**ChiCycle Believe Proposed Modifications to Pavements Near the Chichester Mini Roundabout at the Intersection Between Sherbourne Rd and Westgate will Contravene the Equality Act 2010**

Report compiled by Mark Record June 2021

Outline Planning Permission for Phase 1 of the Chichester White House Farm development 14/04301/OUT includes legal agreement document (SECTION 106 PLANNING AGREEMENT - 11.04.18 - PART 1 OF 9). Page 98 this document states developers are required to “establish an advisory Infrastructure Steering Group to be managed and led by the County Council”. The purpose of the steering group is to “take forward the preliminary designs for the Highway Works to detailed designs and delivery of the Highways Works prior to their approval by the County Council”.

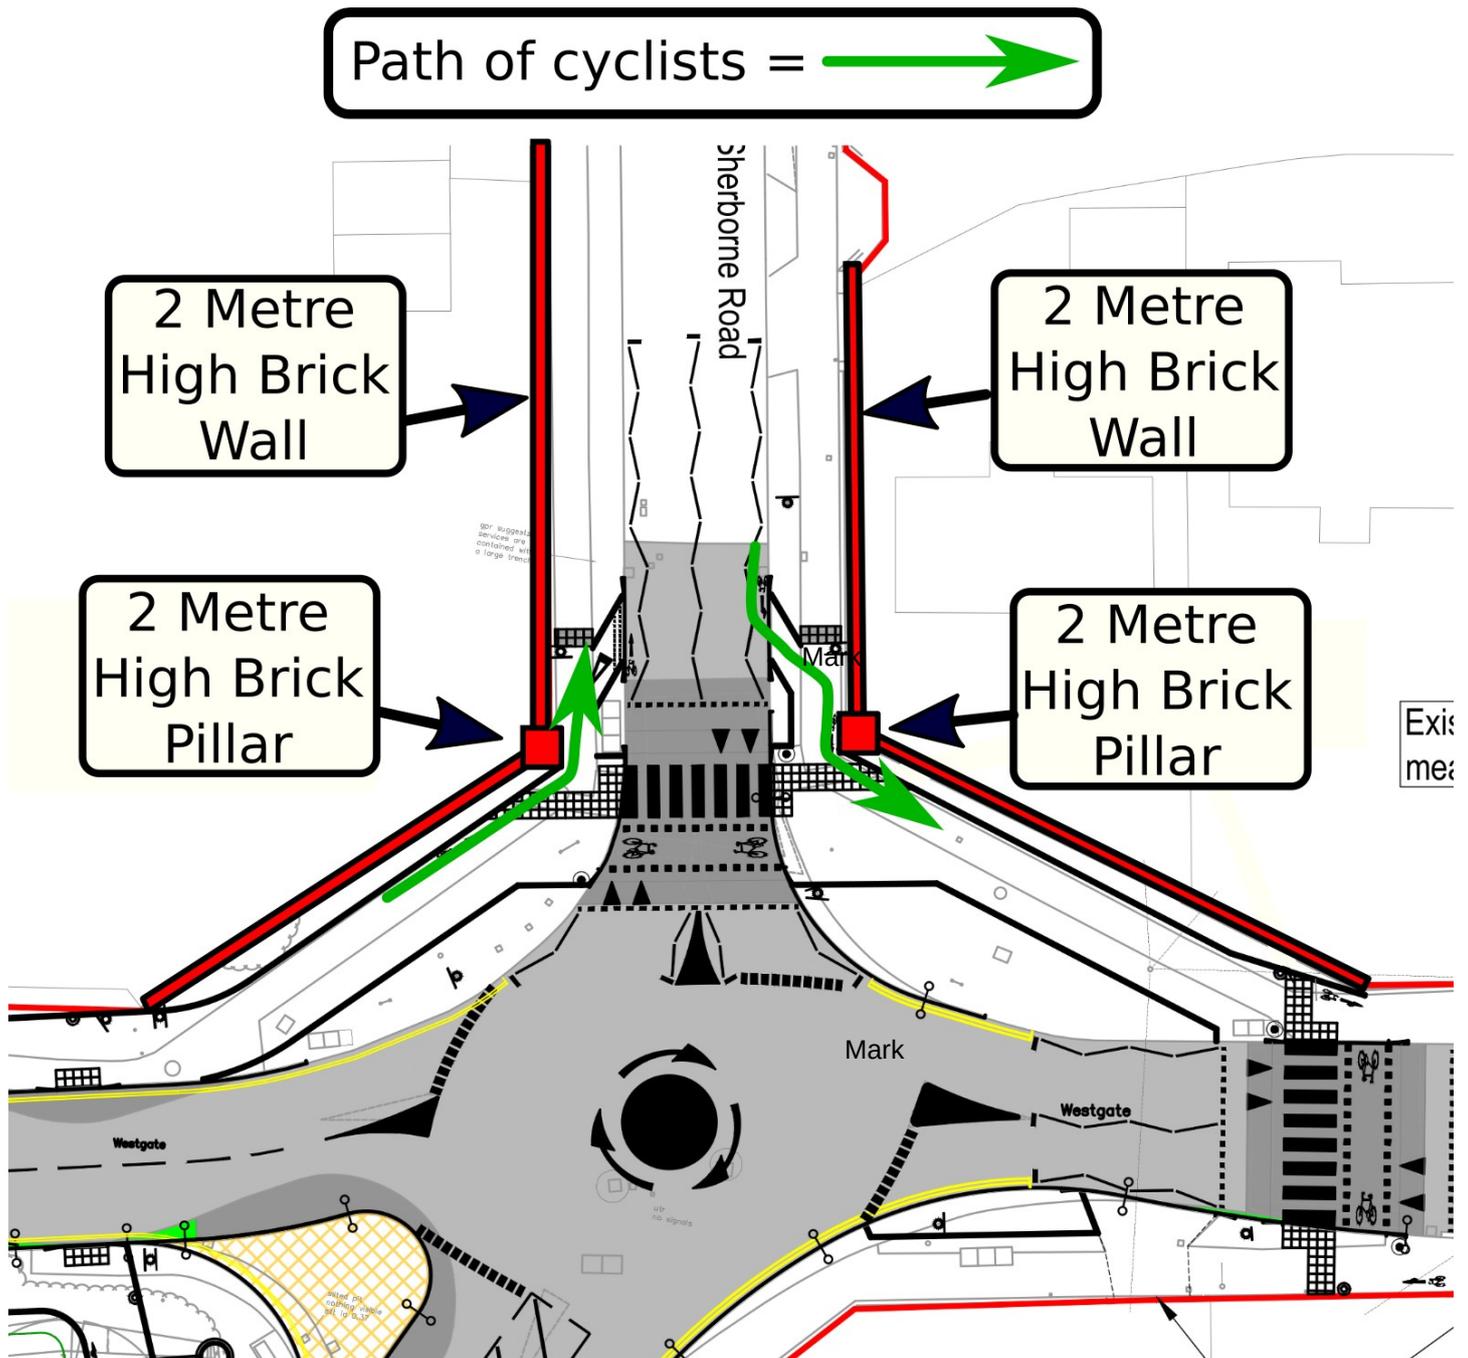
The Northern side of the mini-roundabout is bounded by 2-metre high brick walls. Current proposals re-locate cyclists from the road onto the pavement on a shared use cycle track. Issues are:-

- 1) Cyclists will round corners with virtually zero forward visibility directly into the path of oncoming pedestrians.
- 2) The proposed width of sections of shared cycle tracks are well below minimum widths recommended by DfT. Indeed, shared use cycle tracks are inappropriate in this location according to current guidelines.

The image above shows an annotated clip taken from the currently proposed scheme.

The route of cyclists around blind corners will clearly inconvenience/endoranger pedestrians. Frail elderly members of the community are particularly vulnerable to injury from collisions with bicycles on these blind corners.

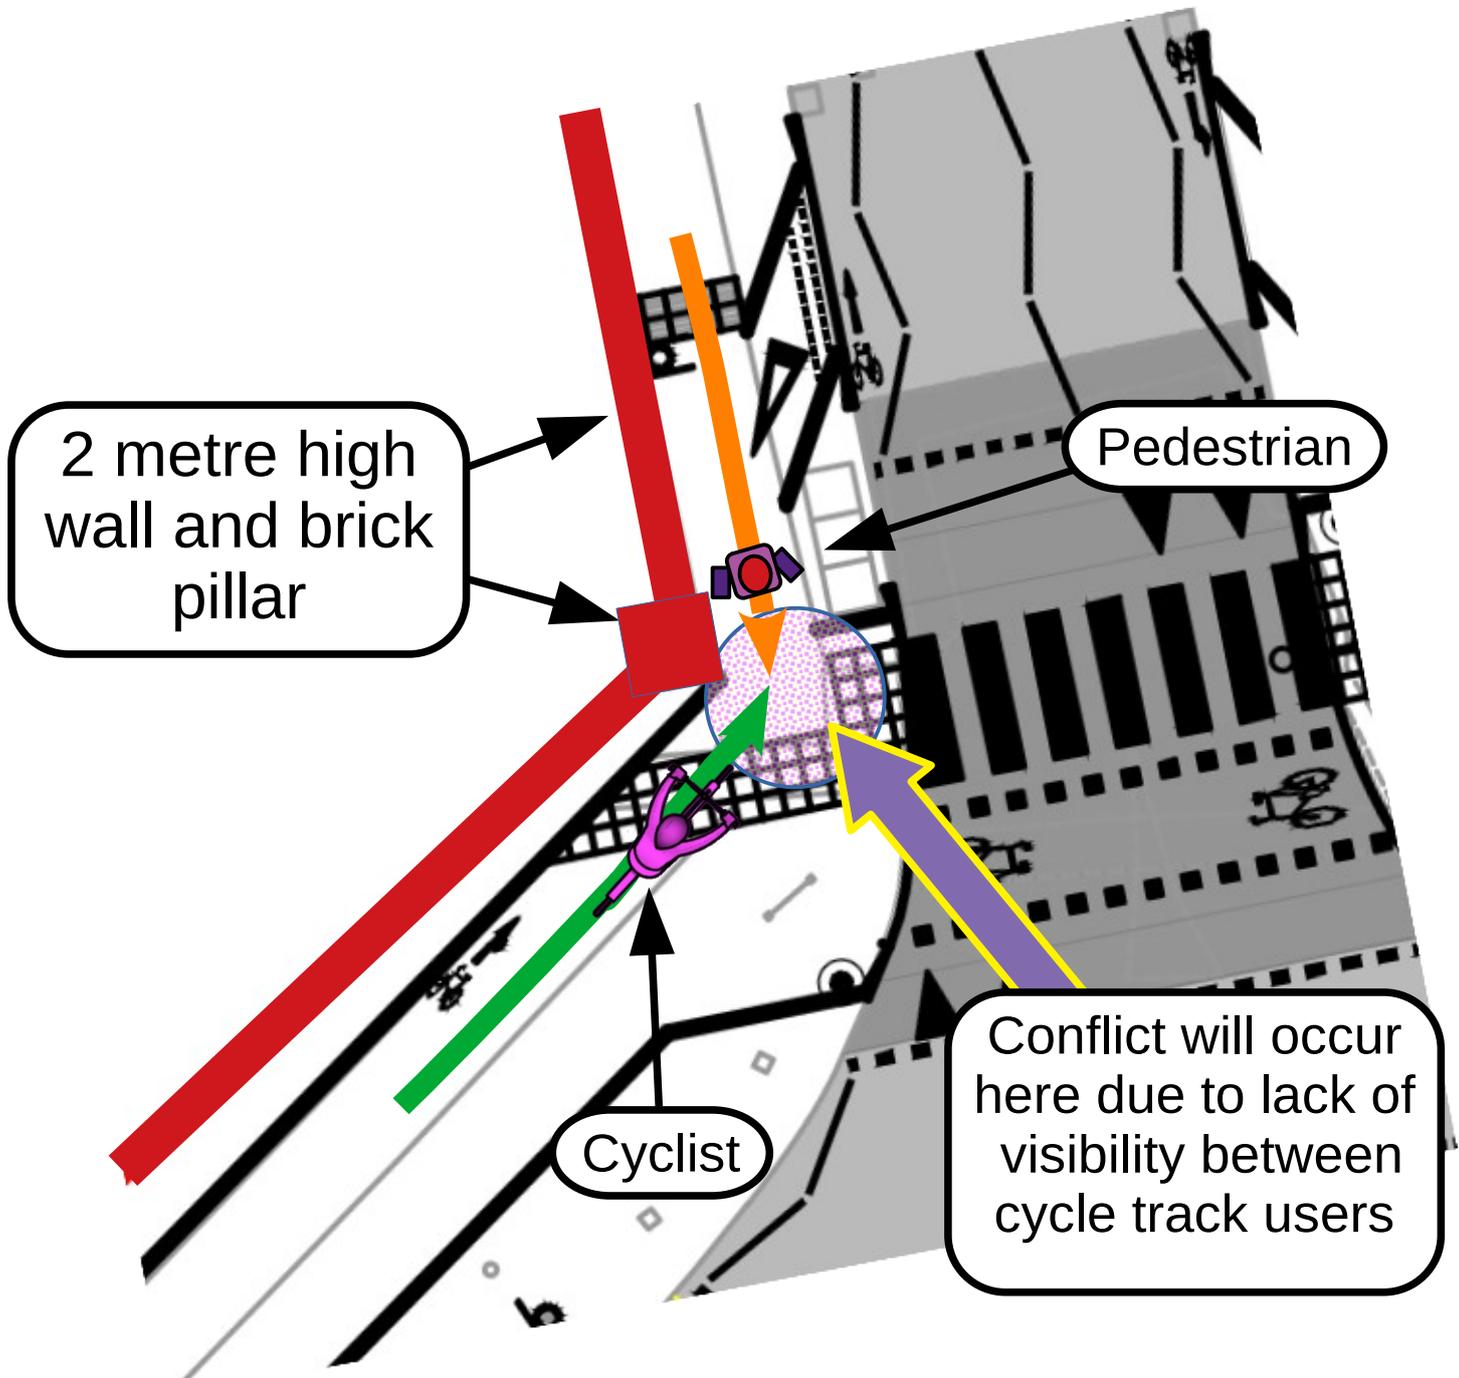
3) Conflict between cyclists and pedestrians will be inevitable on the North West pavement of this roundabout.

*5.9.3 "Objects such as walls, fences and trees should not be sited close to the cycle track on the inside of bends as this will potentially affect the visibility"*

This guidance applies to all new cycle infrastructure (as in this case) but is clearly not adhered to in these proposals. In this example, the apex of the corner is bounded by the edge of a substantial brick pillar and wall, giving no visibility between approaching pedestrians and cyclists

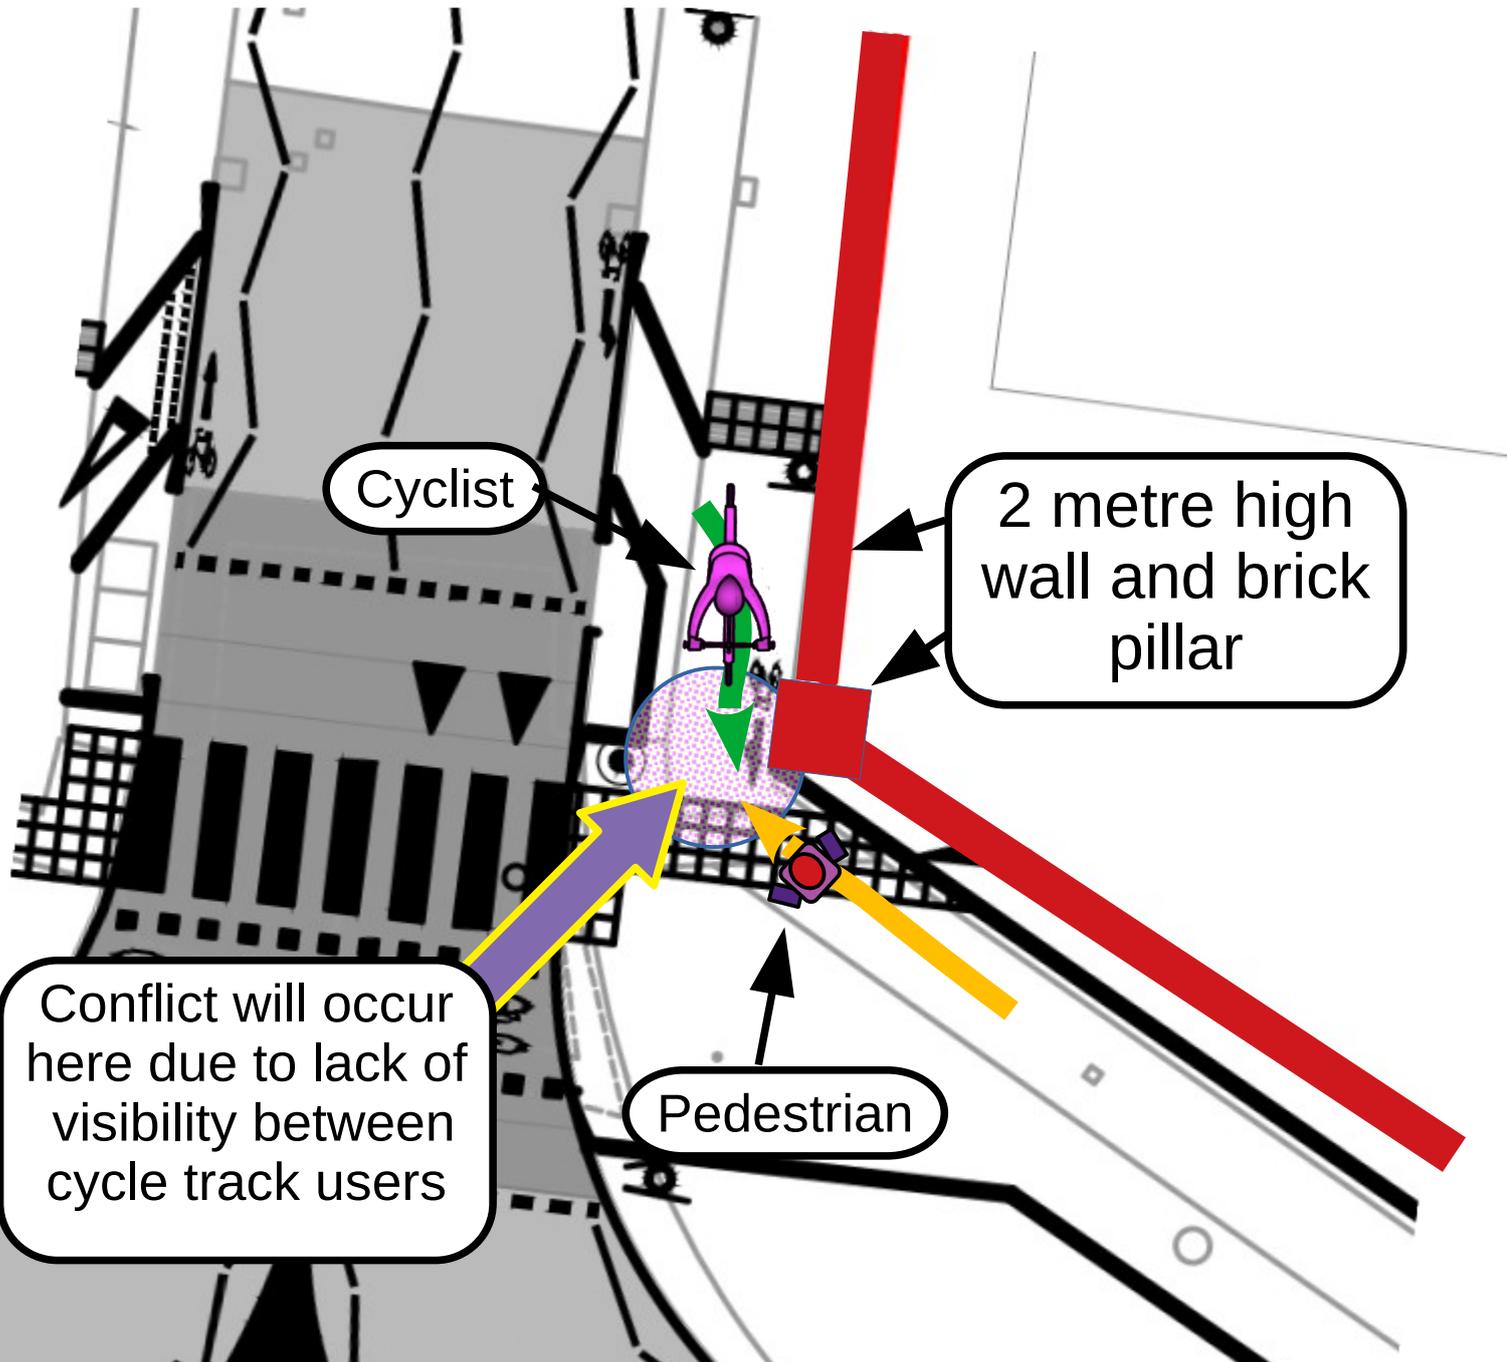
4) Conflict between cyclists and pedestrians will be inevitable on the North East pavement of this roundabout

5.9.3 Table 5-7 provides minimum horizontal curve radii which should be used for cycle traffic on cycle routes including shared use facilities alongside rural highways where there are few pedestrians.

The minimum inside radius given in LTN1/20 Table 5-7 is **four metres** but at the brick pillars this scheme uses a radius of **zero meters**!

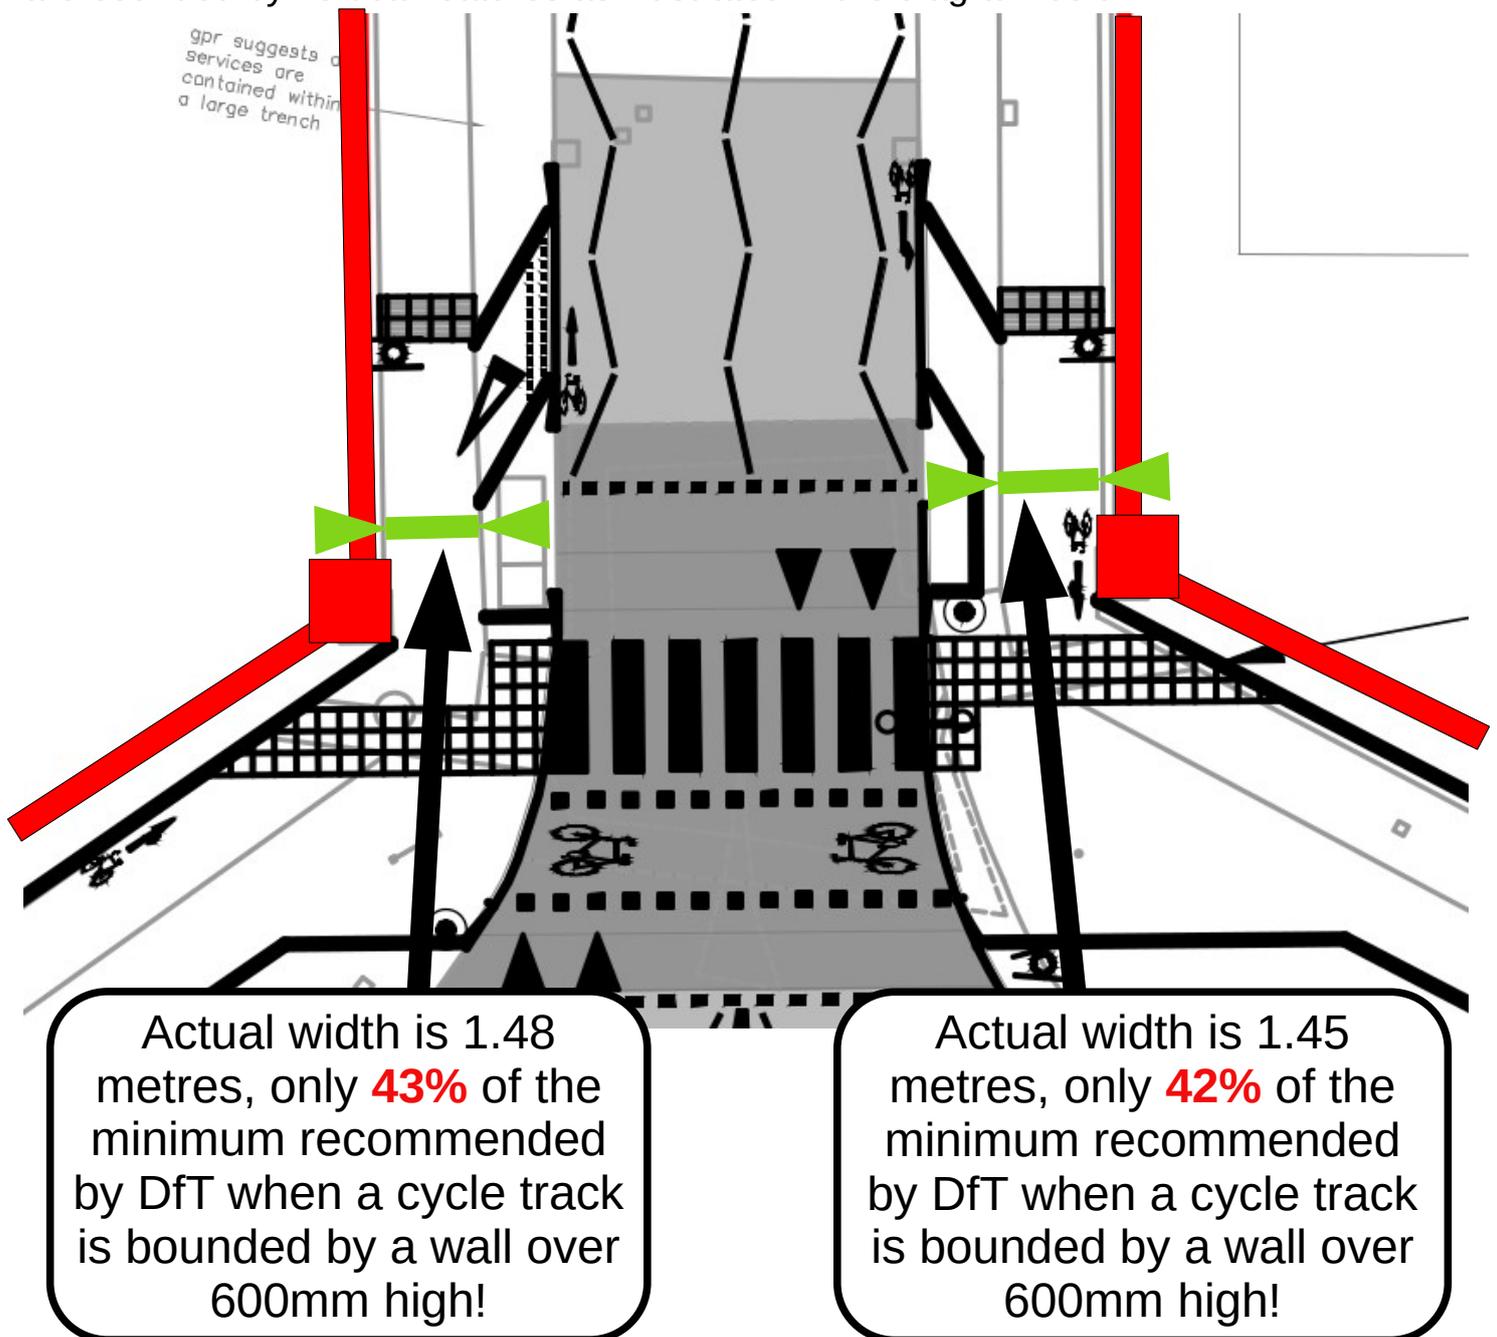
Can it be justified for families to share space at this sharp corner with busy commuter cycle traffic approaching? Will mobility impaired and partially sighted residents feel safe using the proposed infrastructure that will have cyclists rounding this sharp corner without the protection of compliance with DfT forward visibility criteria for shared use cycle tracks?

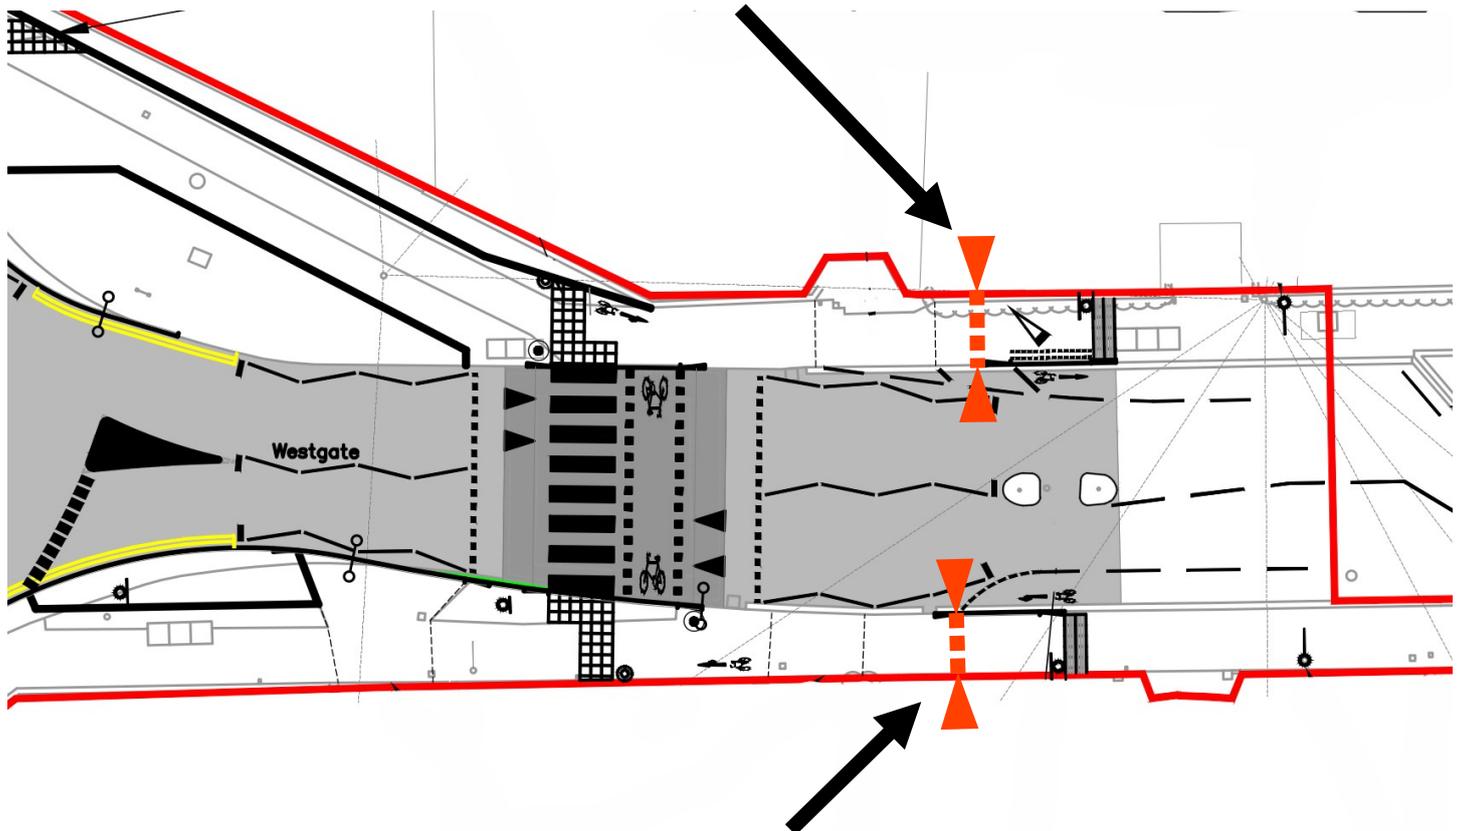
On Westgate north side, the proposed path width is 1.9 metres adjacent to the beech hedge.

LTN01/20 requires a 3.7 metre width track at this location to comply with its guidance.

The proposed width of this shared use cycle track is only **51%** of the minimum width recommended by DfT!
